SUBDIVISION REVIEW SHEET**CASE NO.:** C8-2019-0057.3A**COMMISSION DATE:** January 10, 2023**SUBDIVISION NAME:** Pearson Ranch Phase 2B Final Plat**ADDRESS:** 14320 N FM 620 Road**APPLICANT:** Brett Ames (Pearson Ranch, LLC)**AGENT:** Vanessa Mendez (Dunaway Associates)**AREA:** 22.85 acres**LOTS:** 4**COUNTY:** Williamson**DISTRICT:** 6**WATERSHED:** Lake Creek**JURISDICTION:** Limited Purpose**SIDEWALKS:** Sidewalks will be constructed along Inspire Drive.**DEPARTMENT COMMENTS:**

FINAL PLAT
PEARSON RANCH WEST
PHASE 2B

**CITY OF AUSTIN –DEVELOPMENT SERVICES DEPARTMENT
SUBDIVISION APPLICATION – MASTER COMMENT REPORT**

CASE NUMBER: C8-2019-0057.3A
 UPDATE: U0
 CASE MANAGER: Joey de la Garza PHONE #: 512-974-2664

VICINITY MAP
1" = 2000'

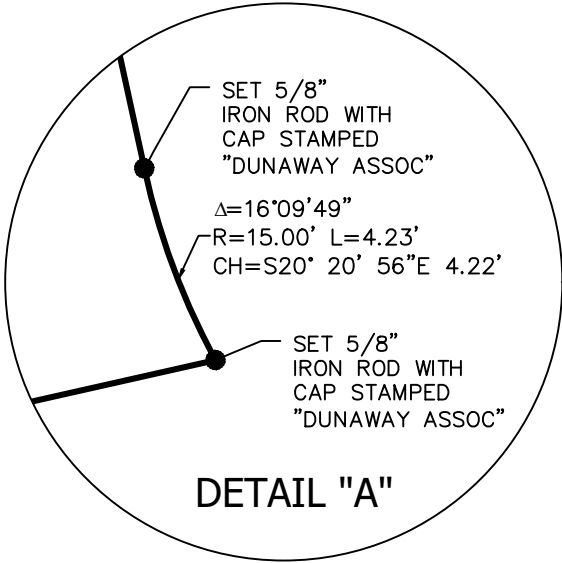
AD2: Please update label for **N SH 45 W** the directional N must be included label the name as shown here in the vicinity map

AD6: Please update label for **W PARMER RD** the directional W must be included label the name as shown here in the vicinity map

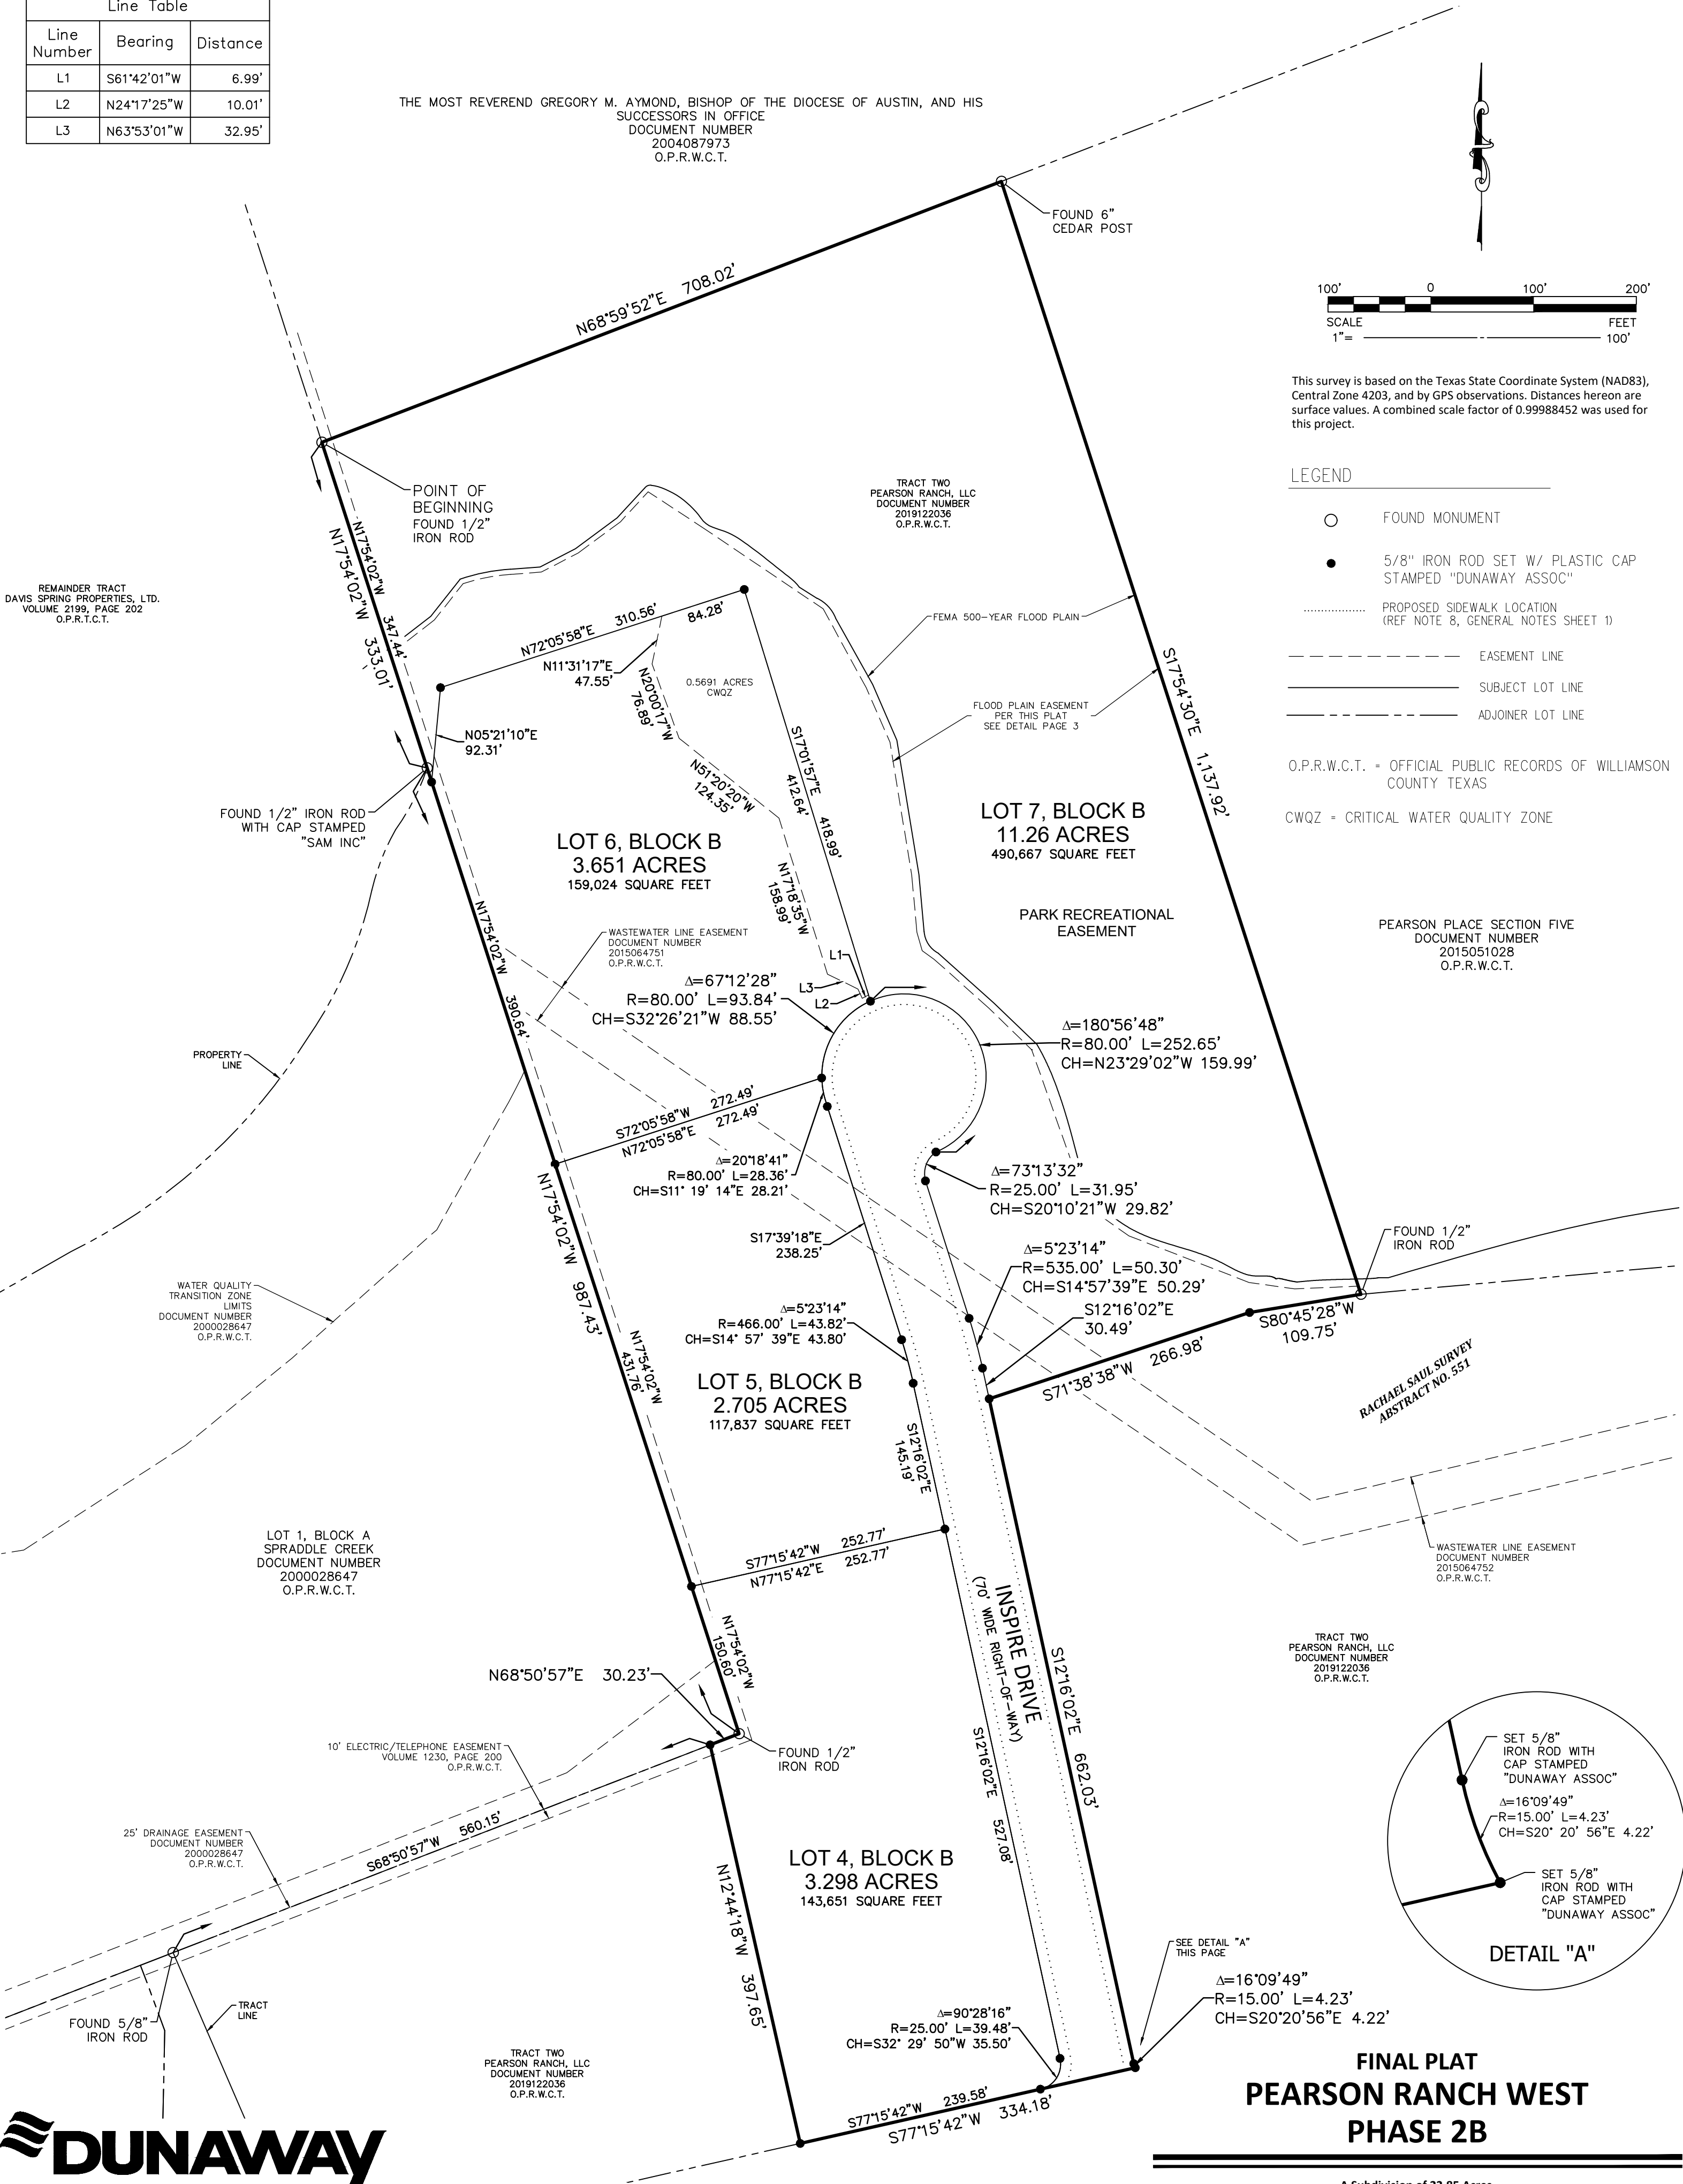
Ten (10') foot electric distribution, electric telecommunications, and electric fiber easement is required adjacent to all street R.O.W. Show the easements on the face of the plat.

DE2: The owner of real property proposed to be developed shall dedicate to the public an easement or right-of way for a drainage facility, open or enclosed, and stormwater flow to the limits of the 100-year floodplain. [LDC 25-7-152]

DE3: Show drainage area maps and calculate fully developed condition flows for the offsite contributing areas passing through site. Drainage easements are required for conveyance of offsite flows through the site. [LDC 25-7-151 & 25-7-152].

SR 3. Remove the tract line and "Rachel Saul Survey Abstract No. 551" from face of plat on sheet 2. 25-1-83

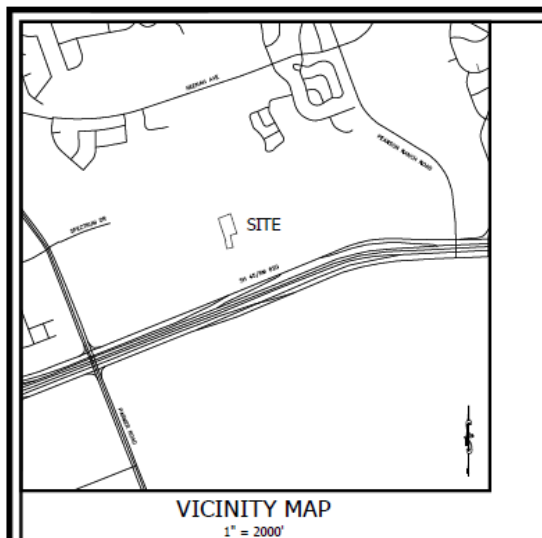
AD4: Please update the extent of the site within the vicinity map. See below for reference.
